APPENDIX 4 SELENIUM

A4.1 Abstract

A4.2 Fate of Selenium in the Environment

Figure 6: Spruce No 1 mine crosssection locations

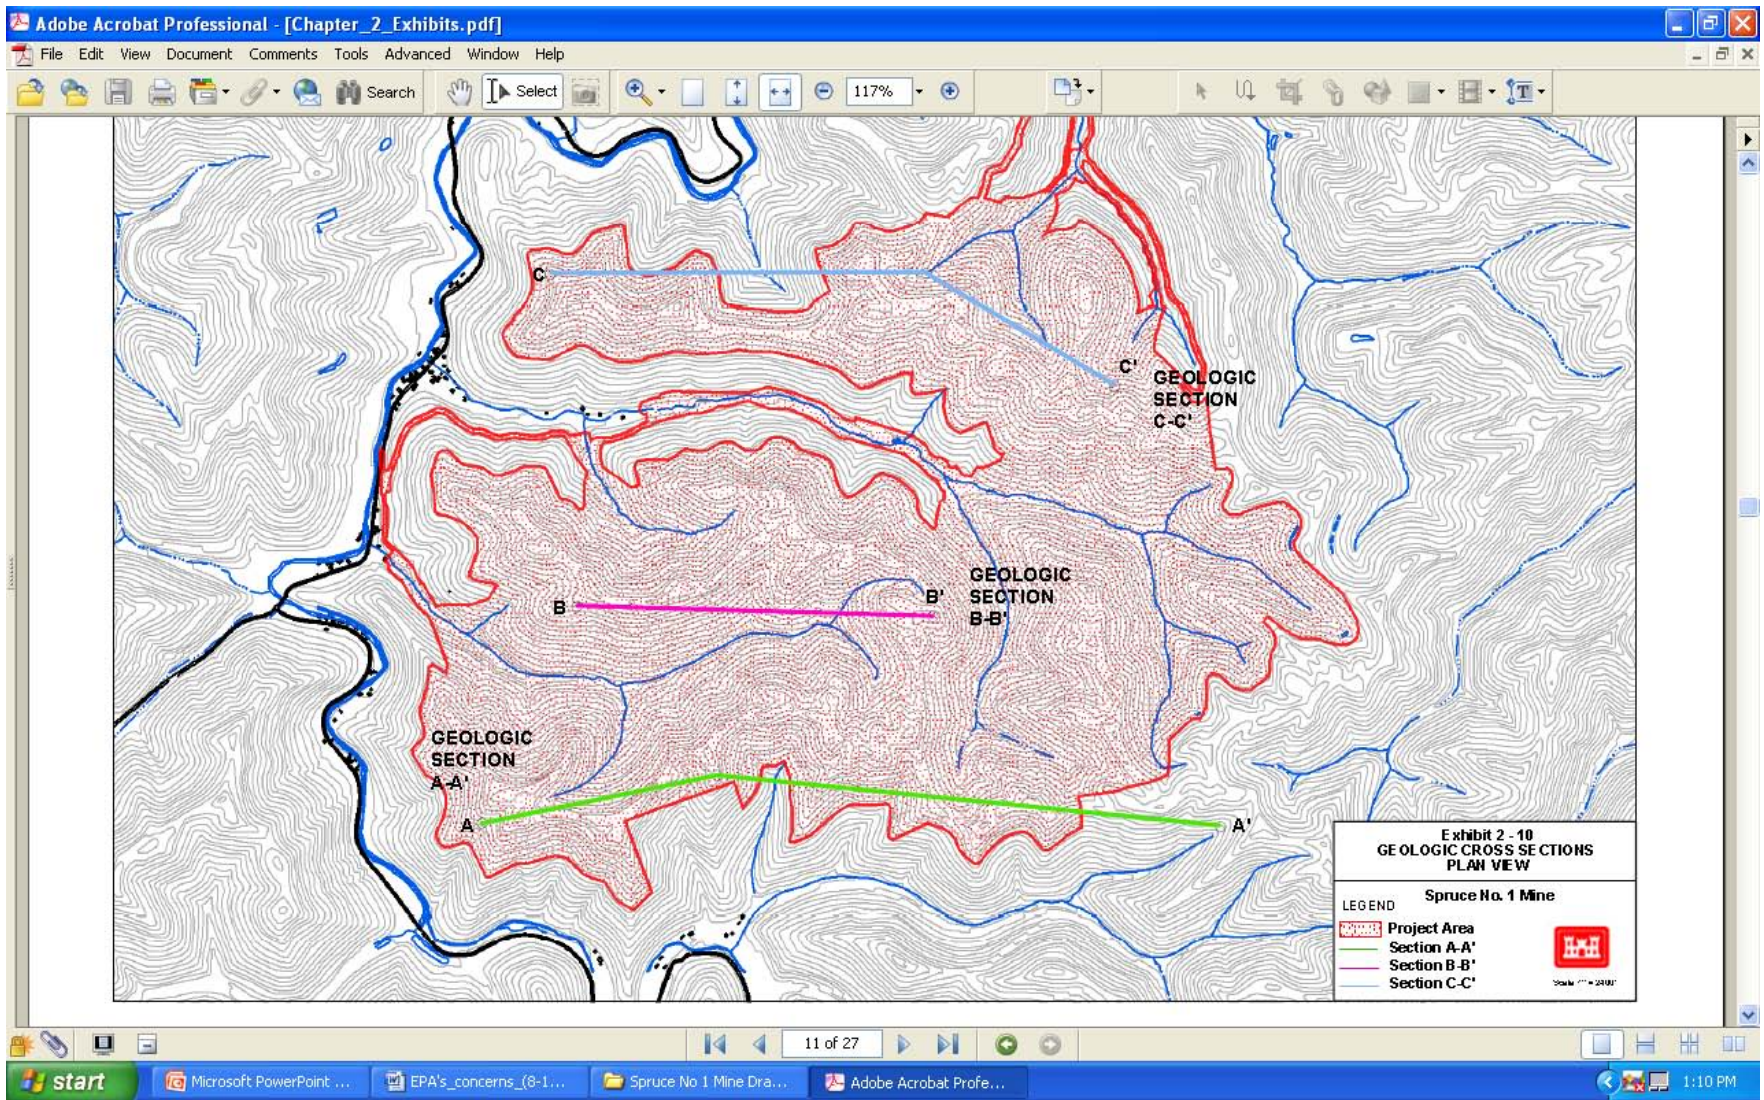
A summary review of rock cores and corresponding cross sections for the Del-Tex mines including the Gut Fork mine (Figures 4 and 5) compared to the proposed Spruce No 1 mine (Figure 6) is provided in Table 1. Figure 7 shows the geologic cross section locations across the Gut Fork mine (I & II) and Spruce No 1 mine (III & IV). Table 1 indicates that for the most part, the formations are repeated from the Del-Tex mine complex to the proposed Spruce No 1 mine location. Indeed as stated by the permittee, the same coal beds are proposed to be developed for the Spruce No 1 mine as for the Del-Tex mine. Also, these coal bed sequences are similar to those described in the literature for southern WV coal bed sequences (Figure 1) and the geologic column for the proposed Spruce No 1 mine (Figure 2). Essentially, all the formations in the Del-Tex complex that had in the past showed high Se levels and have led to environmental releases are present in the Spruce No 1 complex. According to the Se data in the rock core column, many of the rock formations above and below the coal beds also contained high levels of Se. For example, the shale rock above the Lower Stockton contains Se as high as 6.63 mg/kg. This rock layer may need to be removed to get to the Stockton and may contribute to Se releases.

Figure 8: Selenium distribution as a function of distance to the coal bed

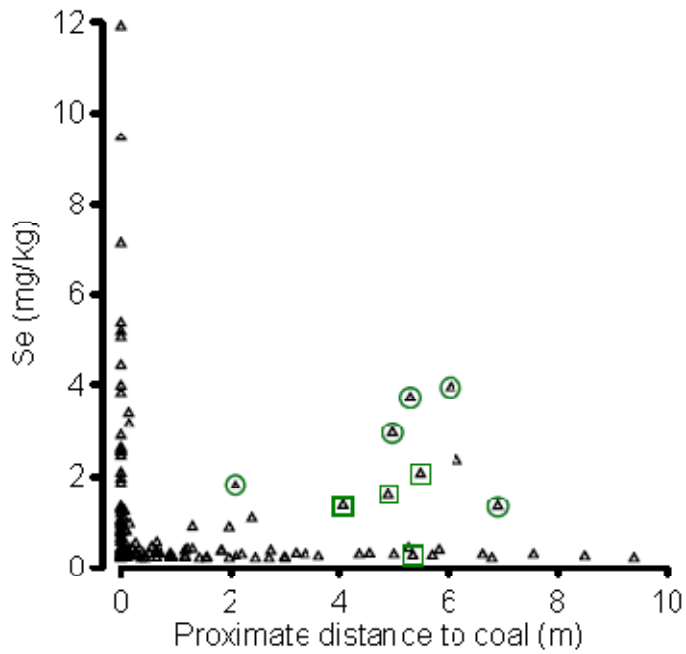
The permittee is proposing to selectively handle high Se bearing materials. A problem is distinguishing which layers to remove and handle separately and which ones to valley-fill. Adequately testing each layer in the field could be impossible. Just because a test at a location indicates that the rock materials above and/or below the coal bed could be valley-filled without any special handling does not mean rock materials 100' (or less) away can also be valley-filled without being tested. Microscale spatial differences in Se occurrence and concentrations make it difficult to predict a priori which drilled locations will have high Se concentrations above and below the coal beds. In addition, while Se is highest in coals and rocks that are adjacent to the coals, not all units close to the coal beds are high in Se and not all units away from the coal are low in Se (Figure 8). Even correlations with sulfur (S) and total organic carbon (TOC) are not always strong. Also, extraction data indicates that both organic and sulfide principal component analysis (PCA) show no single trend for Se (Vesper & Rhoads, 2008). Hence, these parameters are unreliable as indicators for Se occurrence. The practice of mountaintop coal mining disturbs large volumes of rock with huge quantities of overburden removed. Given the nature of Se distribution in these overburden materials, it is impossible to demonstrate how an effective on-site separation of high Se-bearing overburden materials will be performed without testing all materials within two to four feet above and below the coal beds.
